Re: Second Submission Review: Parklands Village 1 Phase 2 – Site Plan and Plat
Application Number: DA-2289-06
Case Numbers: 2024-4015-00; 2024-3028-00

PARKLANDS VILLAGE 1 SITE PLAN NO. 2

PARKLANDS VILLAGE 1 SUBDIVISION FILING NO. 2

AMENDMENTS		
AMEND #	DATE	DESCRIPTION
 Know what's below. Call before you dig.		
THE PARKLANDS VILLAGE 1 - SITE PLAN NO. 2 COVER SHEET

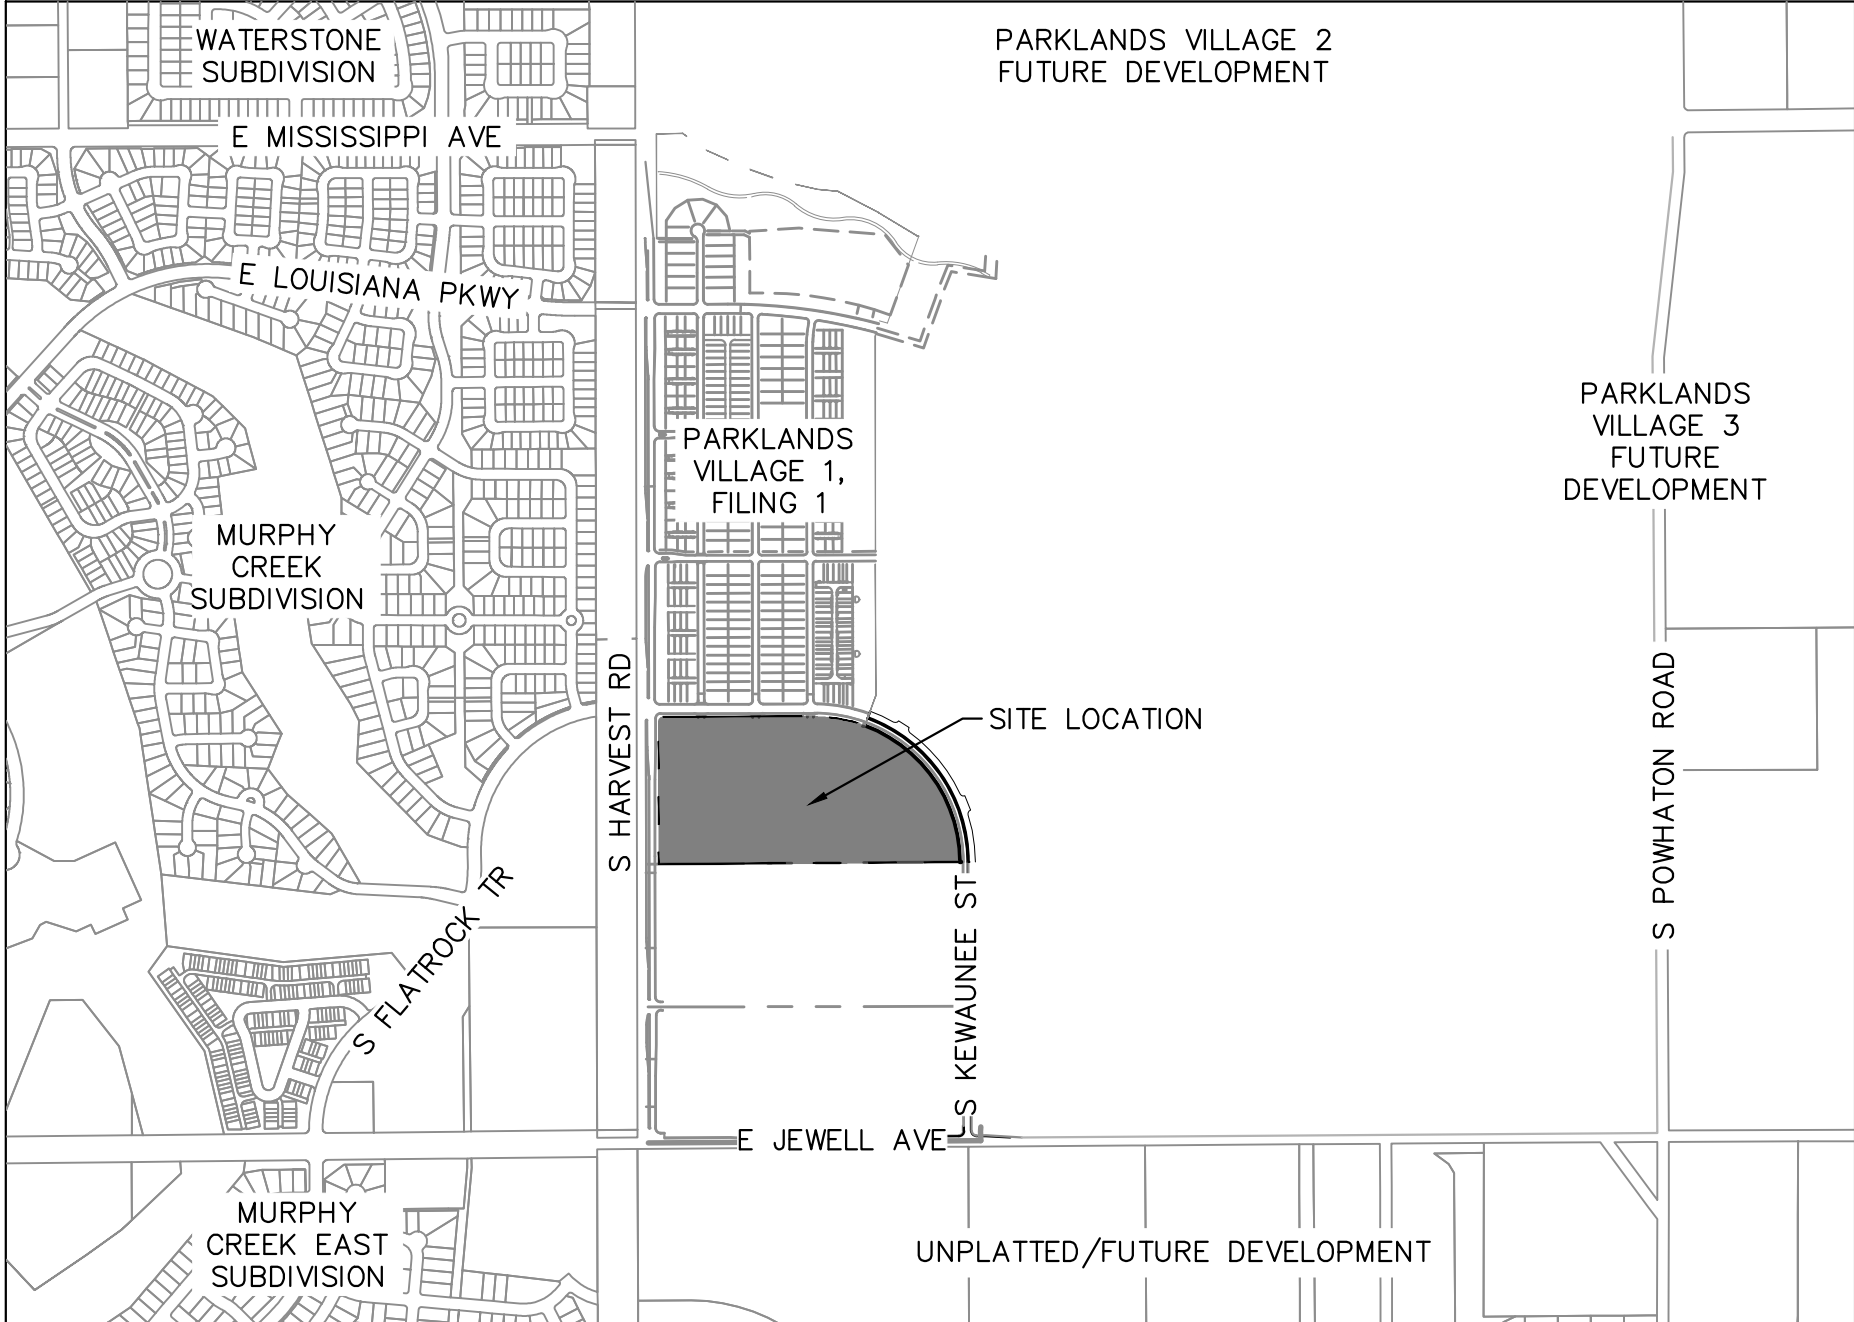
Advisory Comment: Site plan can not be approved until the preliminary drainage study is complete.

Advisory (adding this comment for future reference during subsequent review): The site plan for filing 1 (RSN 1730386) shall be approved prior to the approval of this site plan because it includes necessary infrastructure.

Understood. Thank you for the heads up.

Understood, and agree.

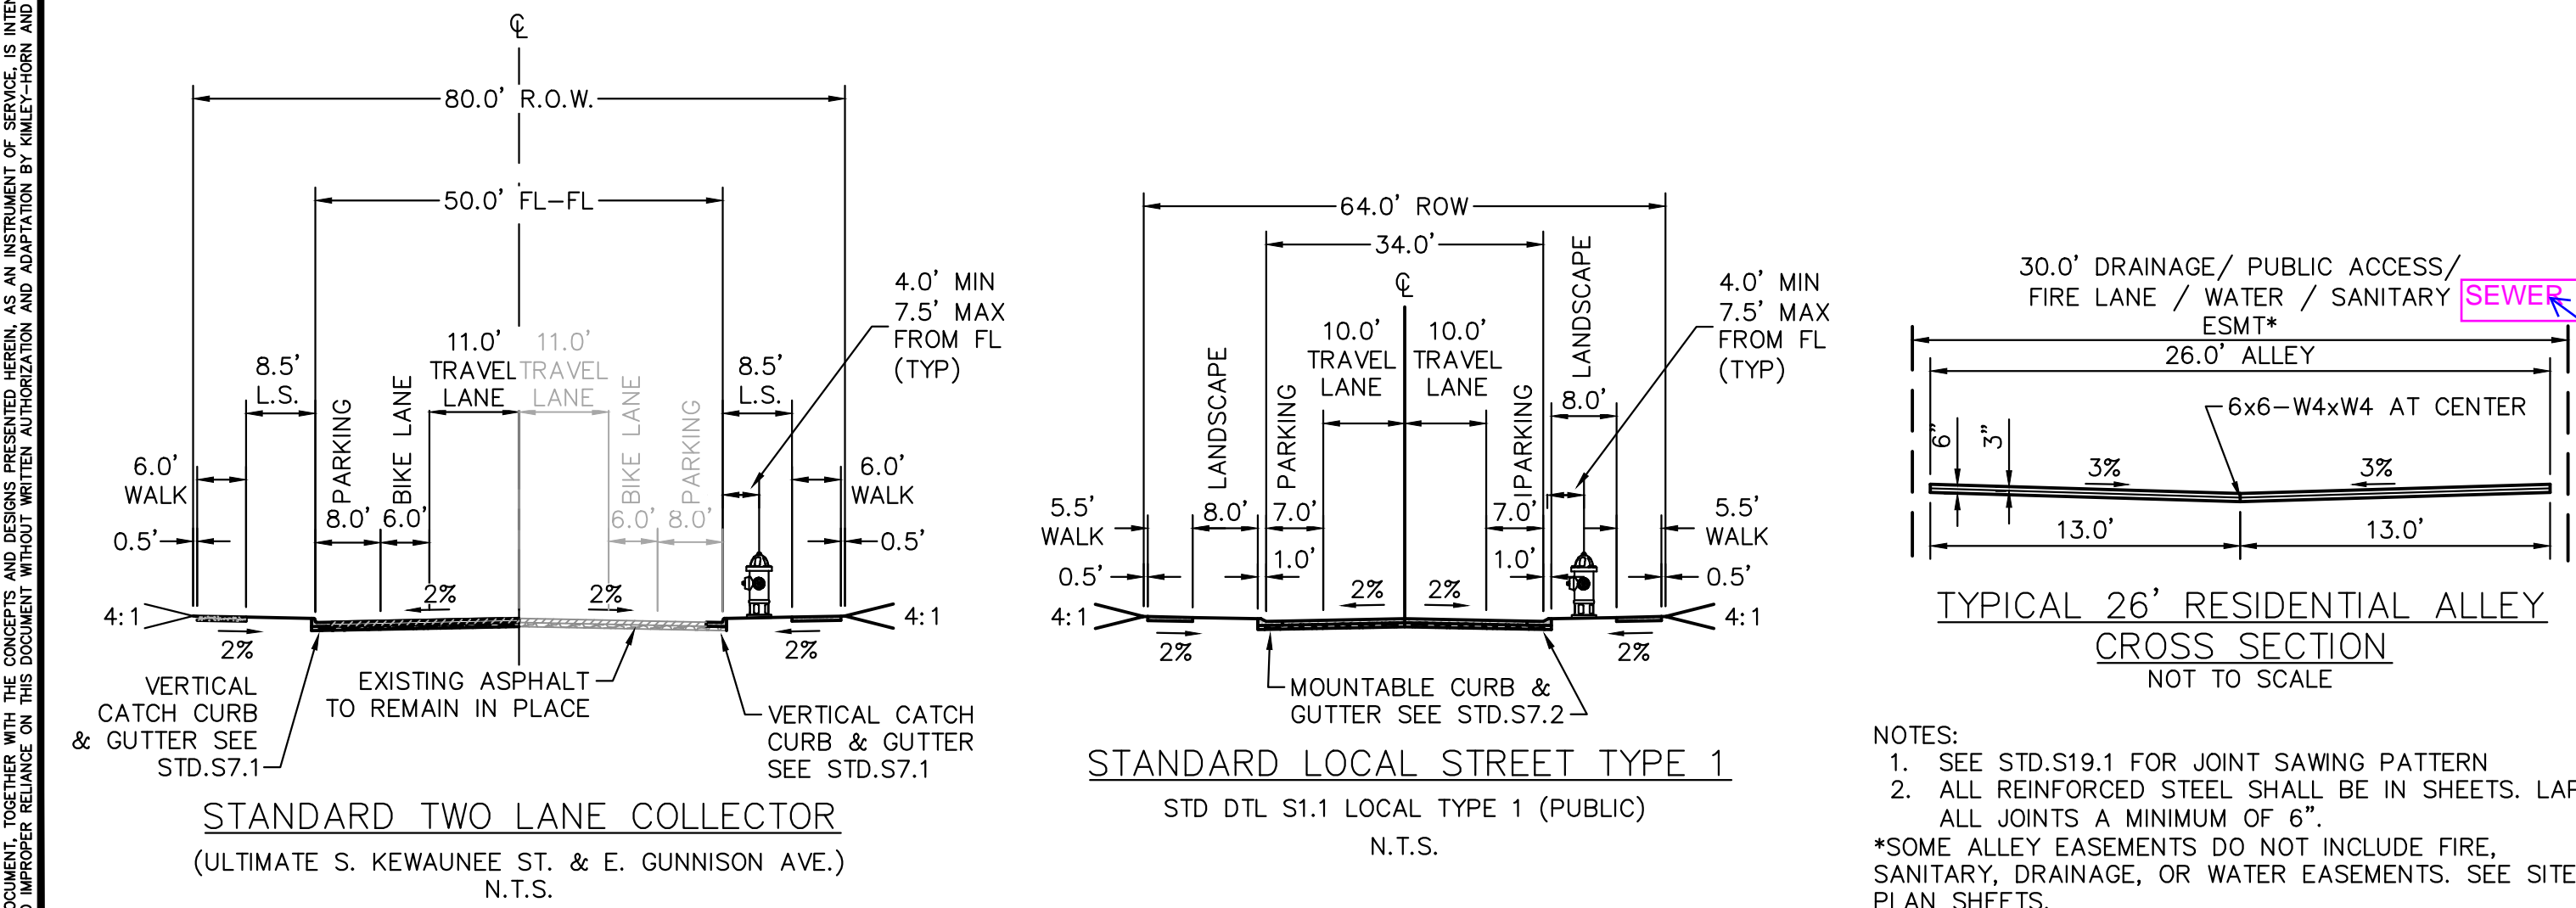
- Photometrics for the public streets will be reviewed/approved on the civil plans.

Table removed from sheet.

Full photometric and street lighting plans to be provided with Final Civil Plan Submittal.
